ADDENDUM 2

DATE: February 22, 2017
PROJECT: JLL Roof Replacement and Waterproofing Project
RFP NO: 744-R1712
OWNER: The University of Texas Health Science Center at Houston
TO: Prospective Proposers

**UNIVERSITY OF TEXAS HEALTH SCIENCE CENTER
JESSE JONES LIBRARY
ROOF REPLACEMENT AND EXTEIOR WALL REPAIRS/RESTORATION
1133 JOHN FREEMAN BOULEVARD
HOUSTON, TEXAS**

**ADDENDUM NO. 1
FEBRUARY 17, 2017**

1 EXISTING ROOF PLAN:
 R2.00 SCALE: 1"=20'-0"(11"x17"); 1"=10'-0"(22"x34")

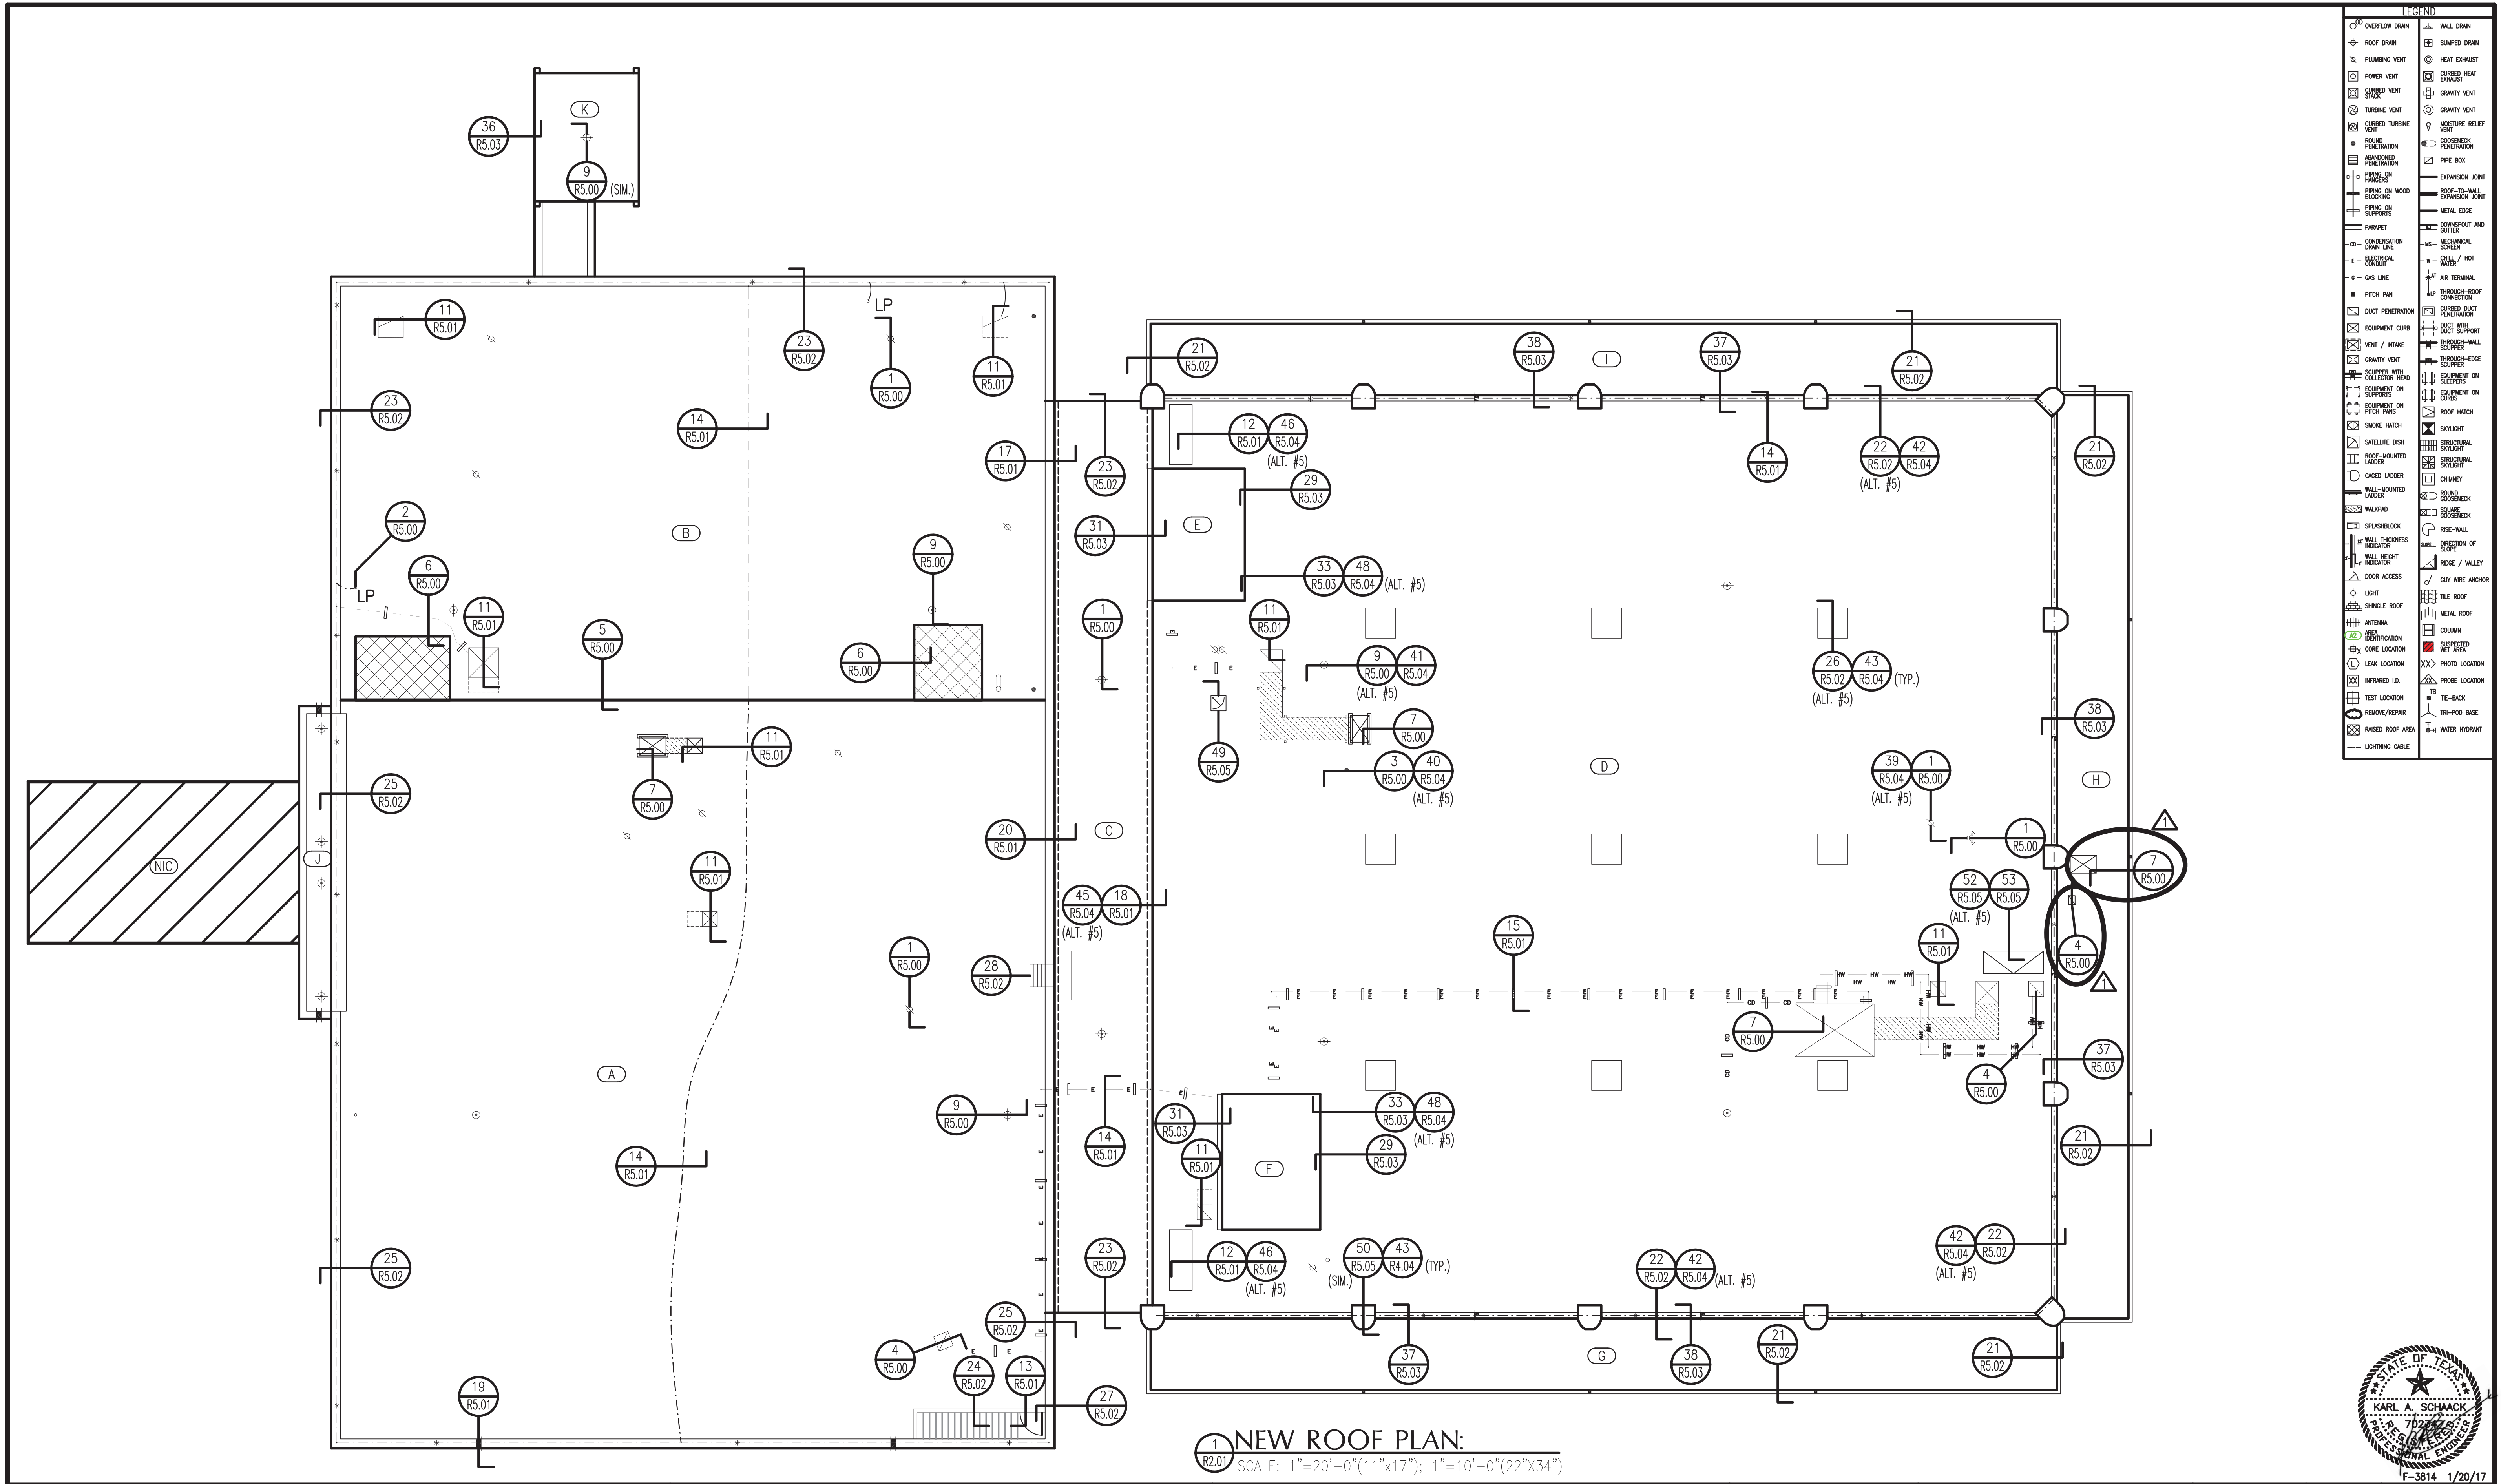
5. Sheet R2.00 – Existing Roof Plan: Add illustration of equipment supported by sleepers and pipe box penetration on roof Area “H”. Reference attached revised Sheet R2.00.

1 NEW ROOF PLAN:
 R2.01 SCALE: 1"=20'-0" (11"x17"); 1"=10'-0" (22"x34")

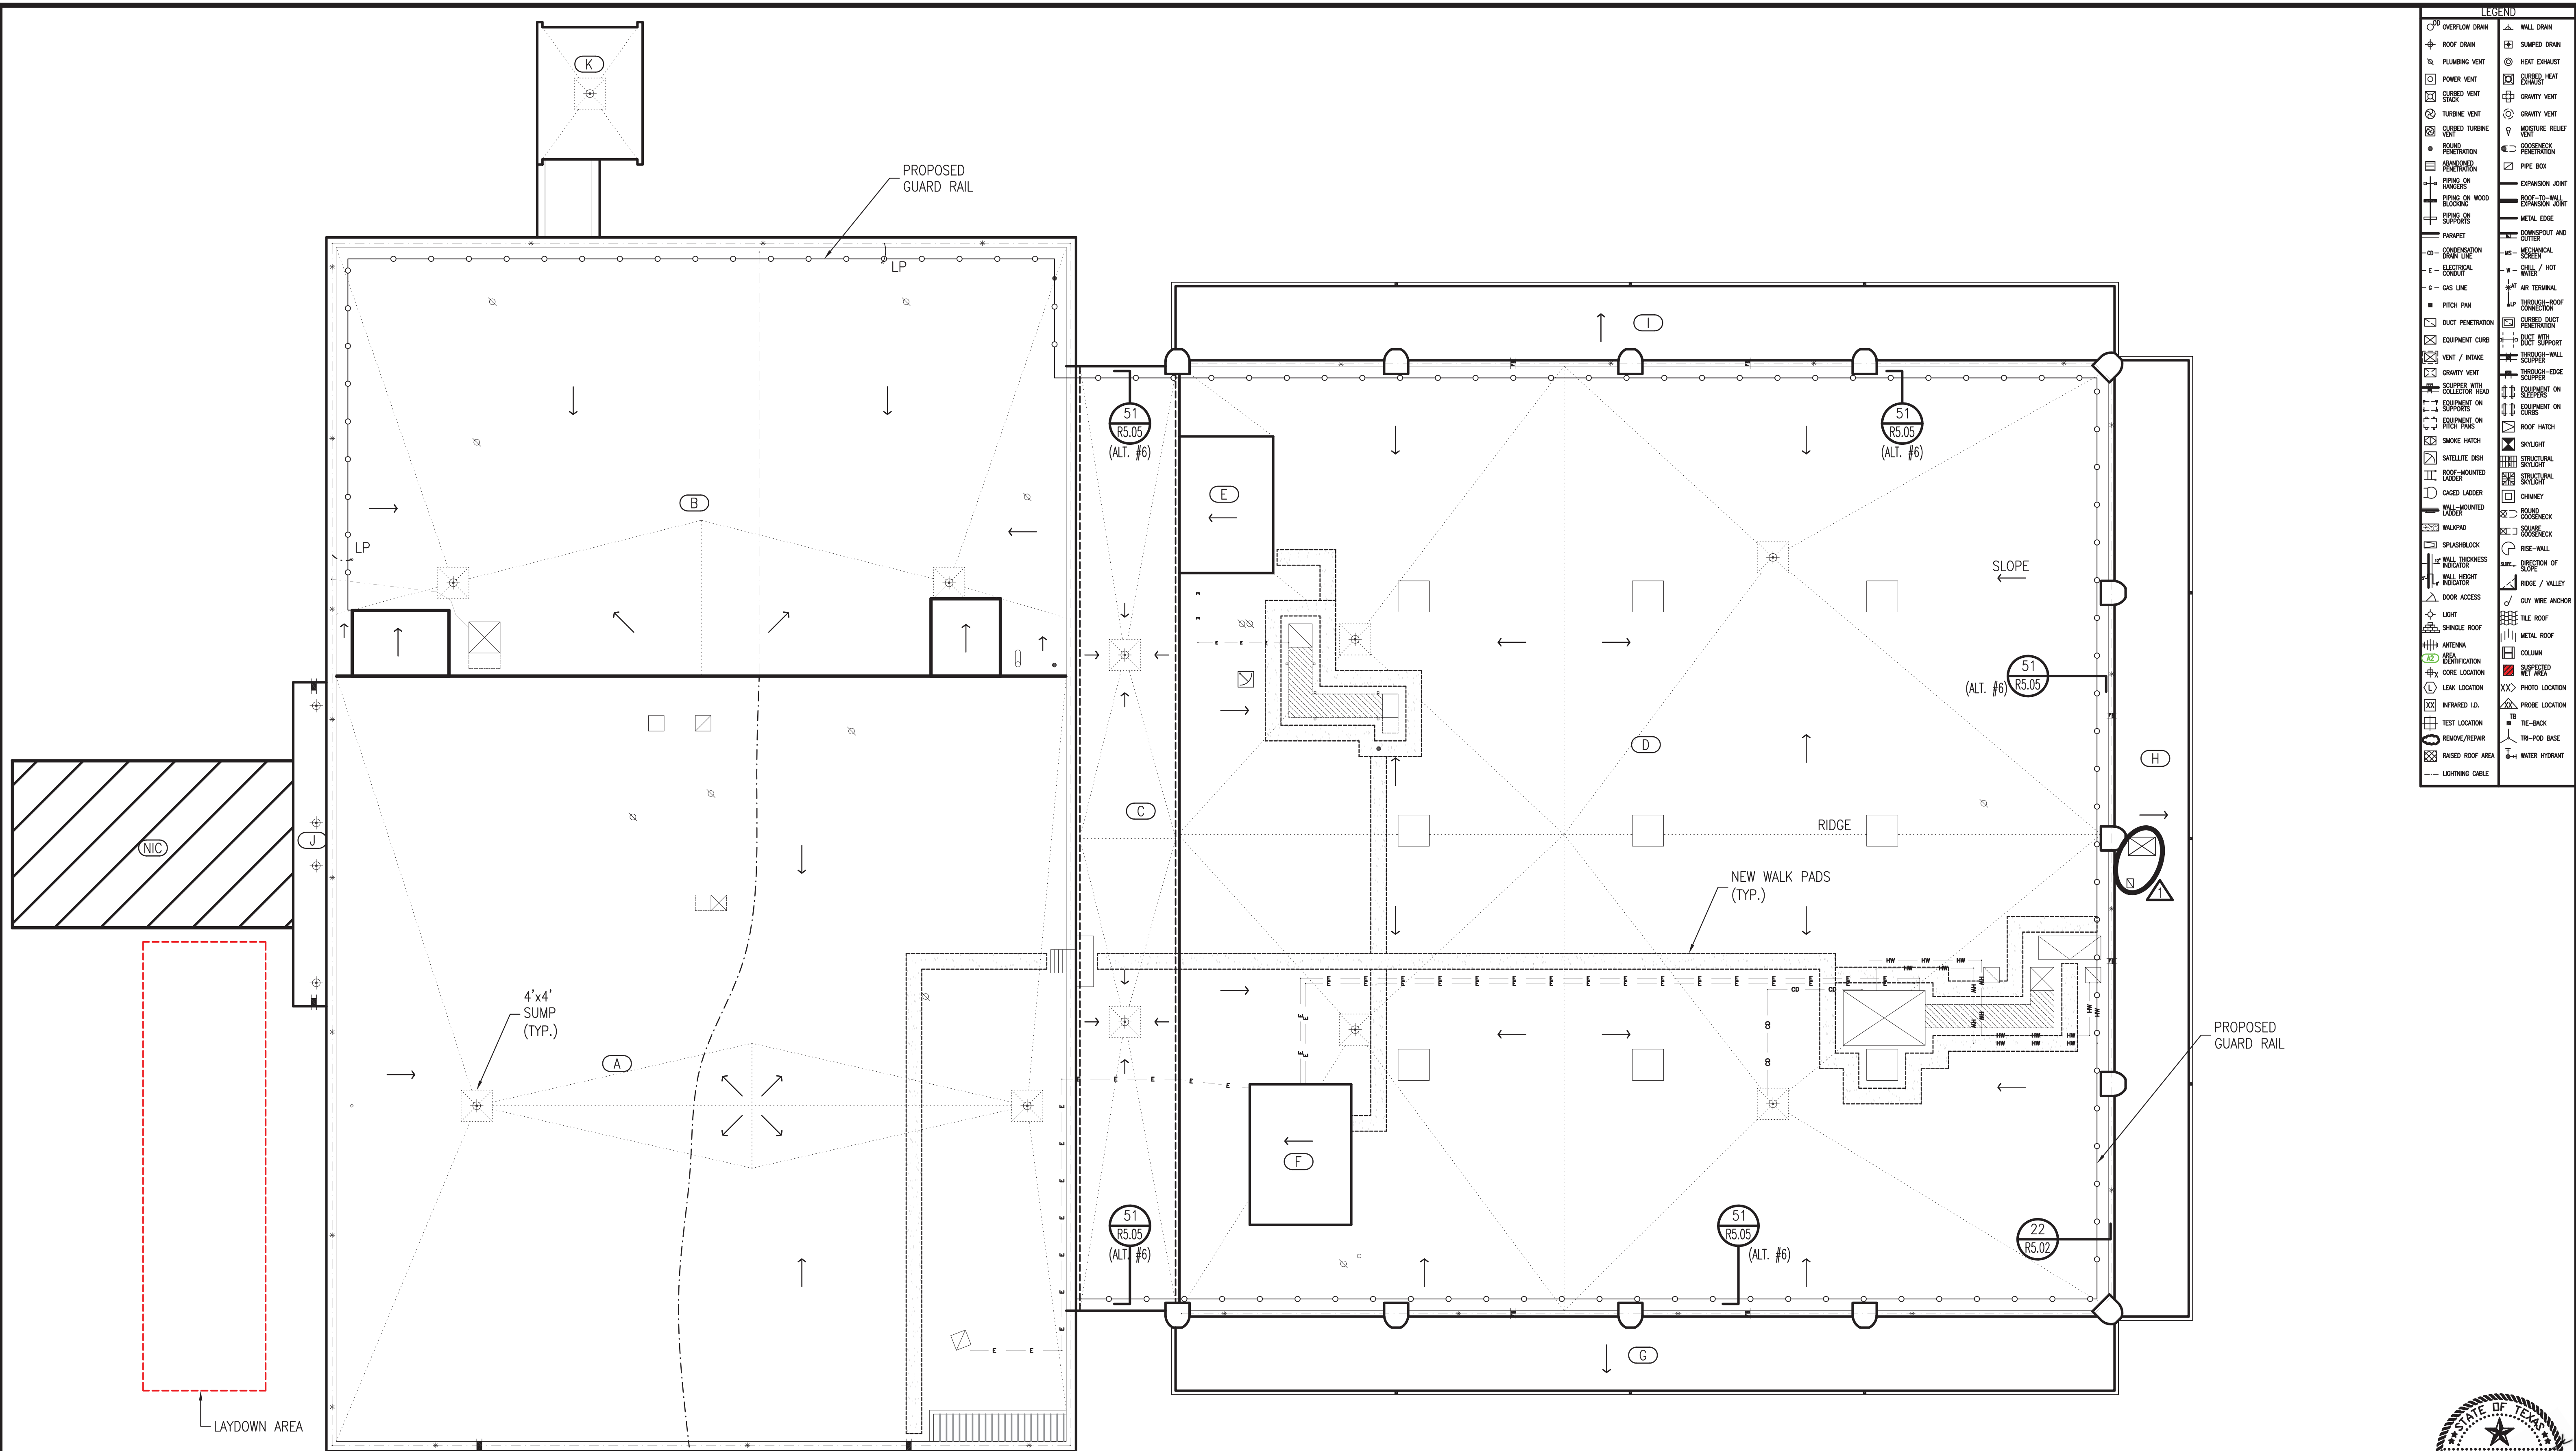
6. Sheet R2.01 – New Roof Plan: Add illustration and detail designations of equipment curb and pipe box penetration on roof Area “H”. Reference attached revised Sheet R2.01.
